Official Transcript of Proceedings
NUCLEAR REGULATORY COMMISSION

Title: Advisory Committee on Reactor Safeguards
SHINE Subcommittee

Date: Friday, October 21, 2022

SHINE SUBCOMMITTEE

Figure 7.3-1 – Process Integrated Control System Architecture

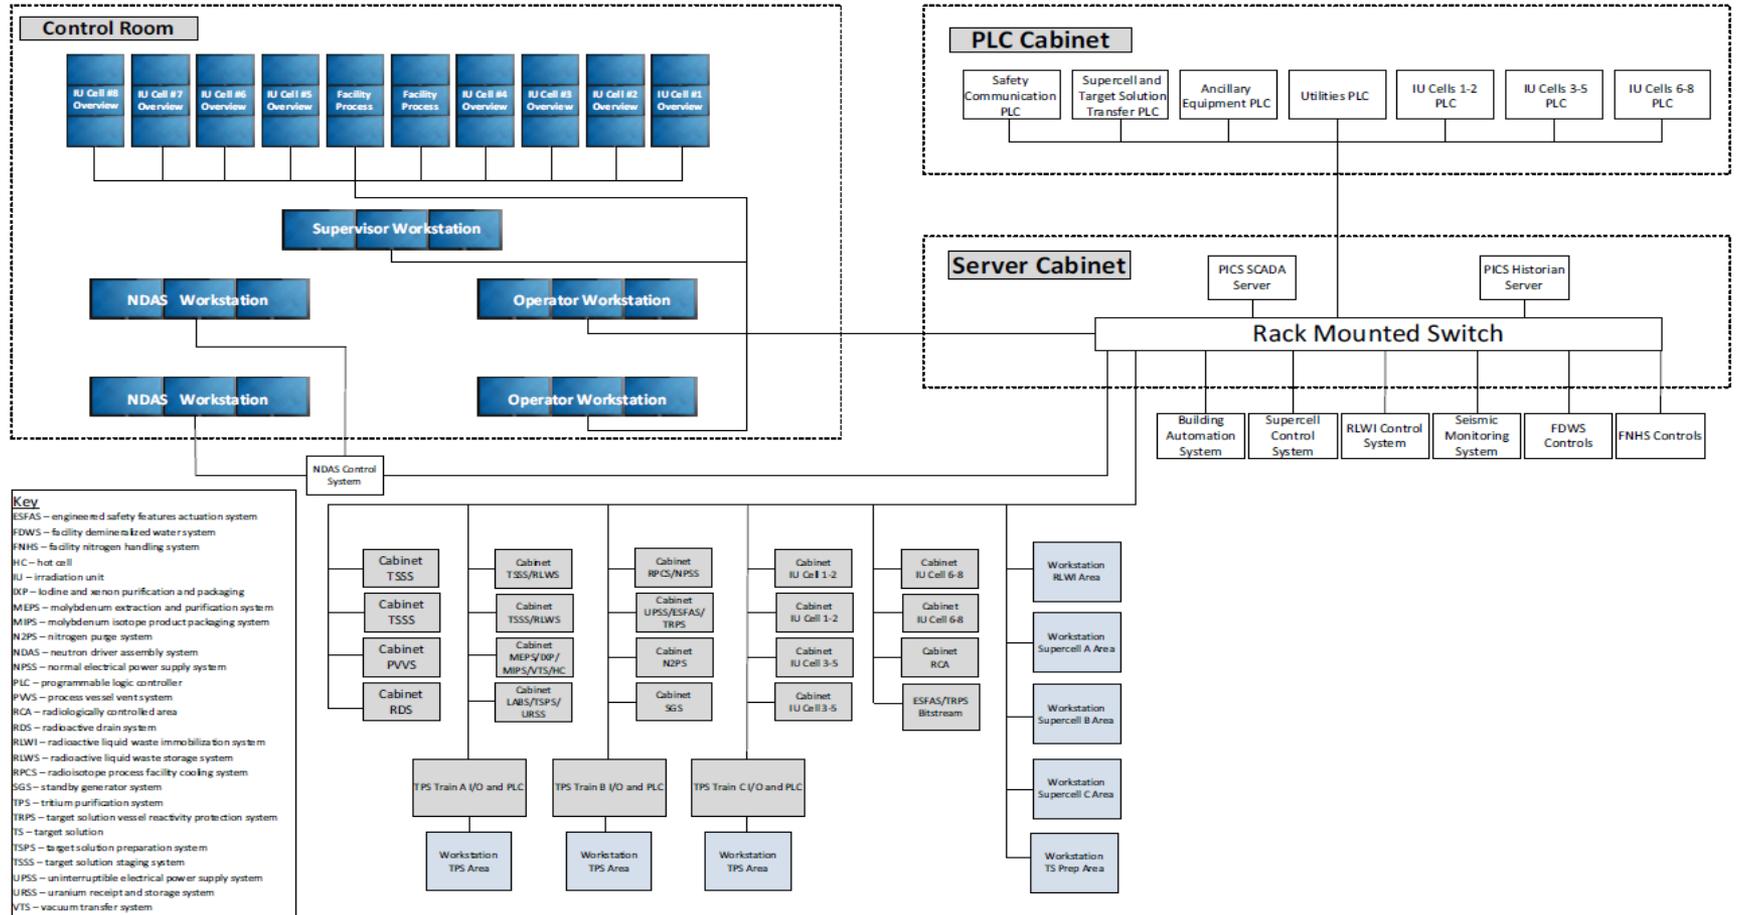
1 things you have to control. So, fundamentally,
2 there's a giant server where all the software is
3 located for these systems. They're not separate PLCs
4 for every system. Is that a correct assumption, for
5 other than the ones shown up in the upper block of
6 Figure 7.3-1?

14 MEMBER BROWN: Okay. So there is a -- so
15 this is stuff is, fundamentally, fed into -- if that
16 server fails, what happens? You lose all your
17 controls?

7 MR. MYERS: There are separate PLCs split
8 up by system. On the PICS side, there are five
9 separate, well, actually, seven PLCs and then three
10 for TPS. Those are split up, but they do communicate.
11 They're virtual machines, like HMI screens run
12 through, are on a stratus fault tolerant server that's
13 located in the server room.

21 MR. ARIZAGA: So, essentially, there is
22 redundancy in that with multiple thin clients, so, if
23 one of the servers goes down, you would have several
24 backup servers that would be able to pick up, so you
25 would have no interruption of the actual control PICS.

7 MR. MYERS: Yes. It will switch to the
8 backup server automatically if the primary server were
9 to fail.
